PLAT COMMITTEE

Case Number:	2023-PLT-040
Property Address:	2031, 2033, 2035, 2041, 2047, 2051 and 2053 Ralston Avenue (<i>Approximate Address</i>)
Location:	Center Township, Council District # 17
Petitioner:	Martindale Brightwood Community Development Corporation, by Donna Jo Smithers
Zoning:	D-8
Request:	Approval of a Subdivision Plat, to be known as Re-Plat Lots 150, 151, 152, 153, 155, 156 and 157 of Cooper and Perkins Second Addition, dividing 0.674-acre into two blocks for a townhome development.
Waiver Requested:	None
Current Land Use:	Undeveloped
Staff Reviewer:	Allison Richardson, Senior Planner

PROPOSED PLAT

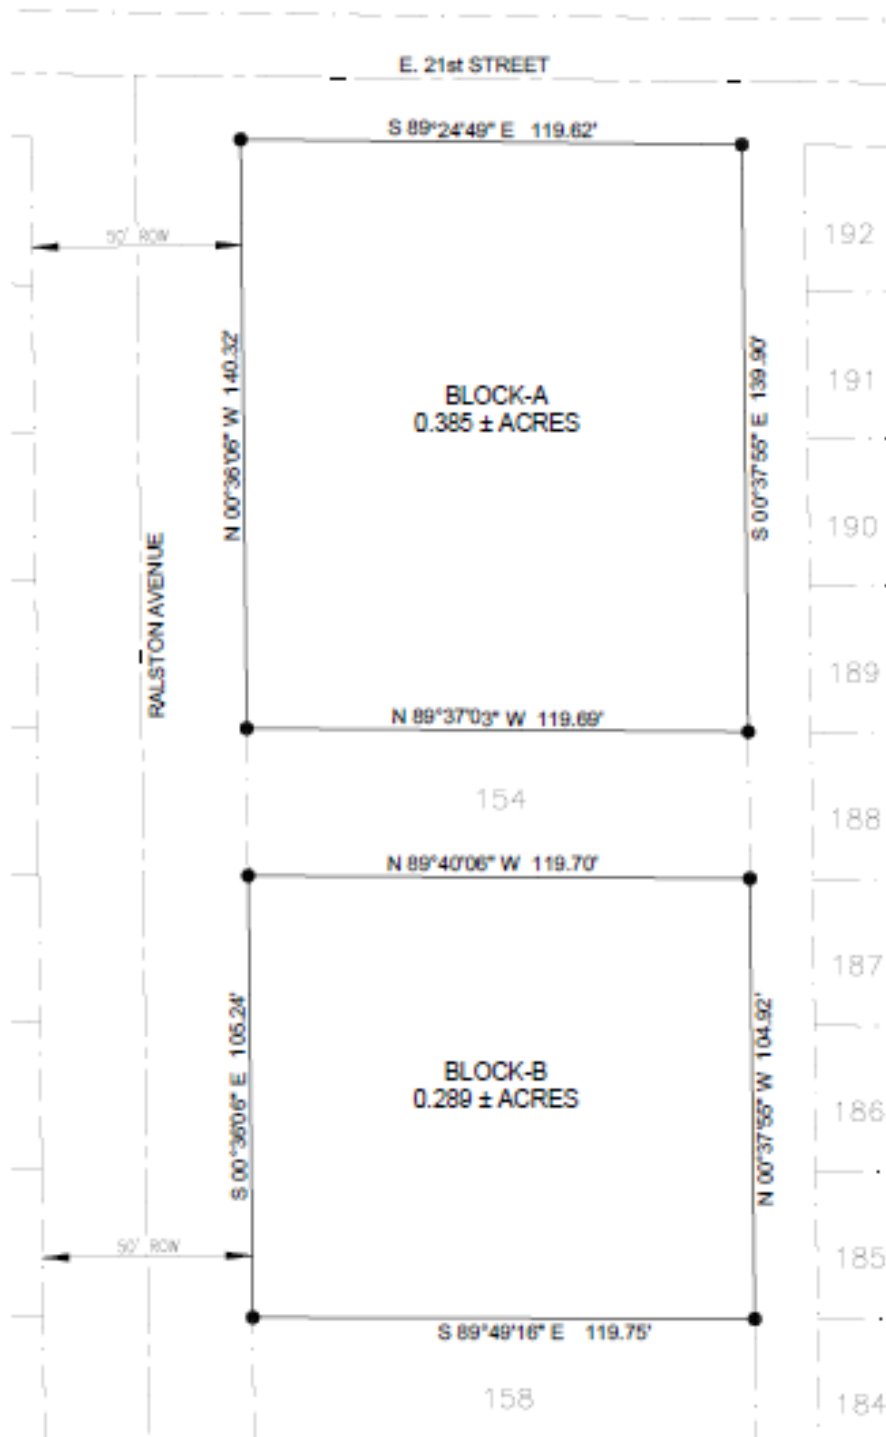
The subject site is zoned D-8 and consists of seven undeveloped lots. This proposed plat would re-plat this property into two blocks—Block A and B. Each block would contain 0.385 acre and 0.289 acre respectively. The proposed plat generally meets the standards of the D-8 zoning classification for a townhome development.

Blocks A and B would front on Ralston Avenue with alley access on the rear. Block A would front on East 21st Street to the north. No new streets are proposed.

Sidewalks are existing on Ralston Avenue. Sidewalks are required on East 21st Street.

Staff recommends that the Plat Committee **approve** and find that the plat, file-dated May 31, 2023, complies with the standards of the Subdivision regulations, subject to the following conditions:

1. That the applicant provide a bond, as required by Section 741-210, of the Consolidated Zoning and Subdivision Ordinance.
2. Subject to the Standards and Specifications of Citizens Energy Group, Sanitation Section.

3. Subject to the Standards and Specifications of the Department of Public Works, Drainage Section.
4. Subject to the Standards and Specifications of the Department of Public Works, Transportation Section.

5. That addresses and street names, as approved by the Department of Metropolitan Development, be affixed to the final plat prior to recording.
6. That the Enforcement Covenant (Section 741-701, of the Consolidated Zoning and Subdivision Ordinance) be affixed to the final plat prior to recording

7. That the Site Distance Covenant (Section 741-702, of the Consolidated Zoning and Subdivision Ordinance) be affixed to the final plat prior to recording.

8. That the Sanitary Sewer Covenant (Section 741-704, of the Consolidated Zoning and Subdivision Ordinance) be affixed to the final plat prior to recording.

9. That the Storm Drainage Covenant (Section 741-703, of the Consolidated Zoning and Subdivision Ordinance) be affixed to the final plat prior to recording.
10. That the plat restrictions and covenants, done in accordance with the rezoning commitments, be submitted prior to recording the final plat.
11. That all the standards related to secondary plat approval listed in Sections 741-207 and 741-208 of the Consolidated Zoning and Subdivision Ordinance be met prior to recording the final plat.
